ICHD - ENVIRONMENTAL HEALTH DIVISION

PERMIT # AP 314469

SEPTIC: IMPROVEMENT PERMIT / AUTHORIZATION TO CONSTRUCT / OPERATION PERMIT / EXISTING SYSTEM

SOIL/SITE EVALUATION
for ON-SITE WASTEWATER SYSTEM
(Complete all fields in full)

INITIAL SITE SKETCH

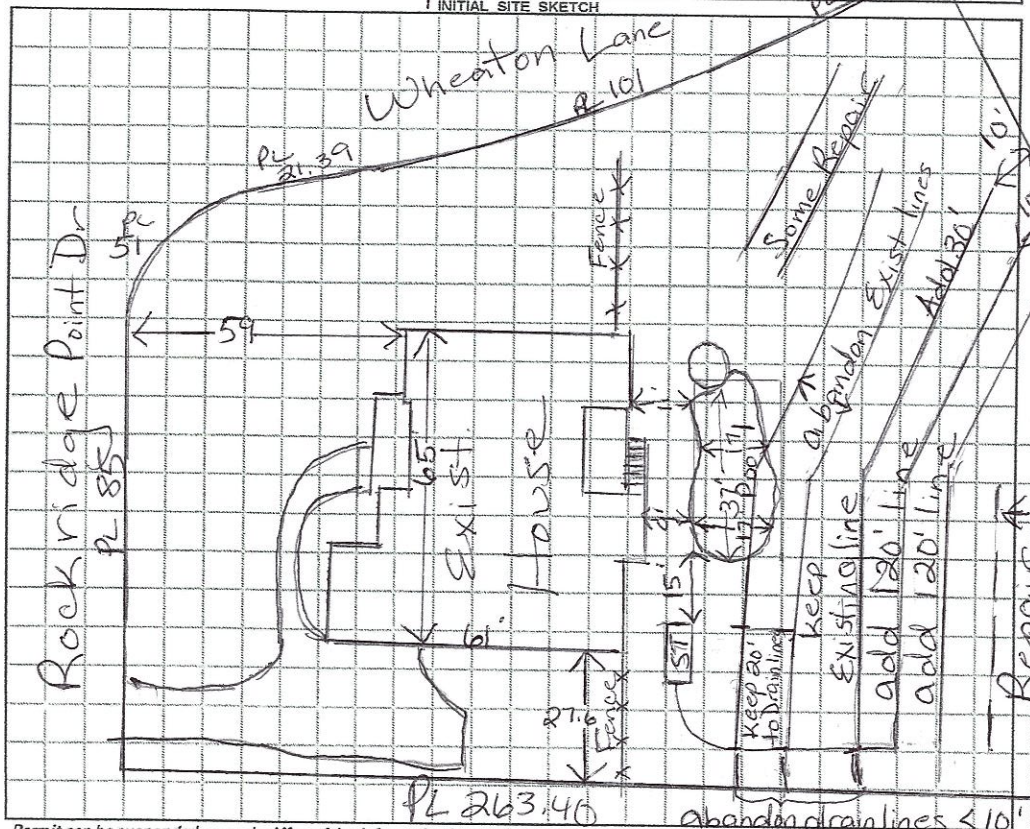
Comments / Conditions: (1) Abandon existing drain lines that are to close to PL (keep 10ft from PL) (2) Keep 20ft of upper 2 drainlines abandon drainlines ≤ 15 to pool cut. (3) Add 30' to end of existing lower drain line (4) Install 2 new drain lines below existing drainfield @ 120 eq. Pool Size 36'9" X 17'
